**Environmental
Protection Agency**

June 28, 2011

RE: COLUMBIANA COUNTY
FAIRFIELD TOWNSHIP
CRESTVIEW PERFORMING ARTS CENTER
CONSTRUCTION STORM WATER

Figure 1 – The rock construction entrance has not been installed.

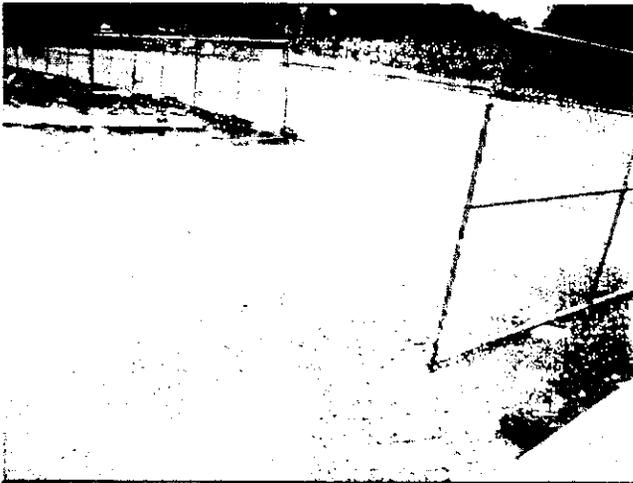
1. The rock construction entrance depicted on the Storm Water Pollution Prevention Plan (SWP3) has not been installed (Figure 1). Please install this sediment control per the detail in the SWP3 in order to prevent off-site tracking of sediment.
2. On many of the storm drains, inlet protection is missing (Figures 2 and 3). On the drains that are protected, the sediment controls are not built to match the inlet protection specifications outlined in the SWP3 (Figure 4). You must install the appropriate inlet protection on all storm drains in accordance with the SWP3.
3. A designated containment area for concrete washout is shown on the SWP3, but is not present on the site (Figure 5). According to the NPDES permit, all water used to clean concrete trucks is considered waste water and must be contained. Please install a concrete washout area, as shown in the SWP3.
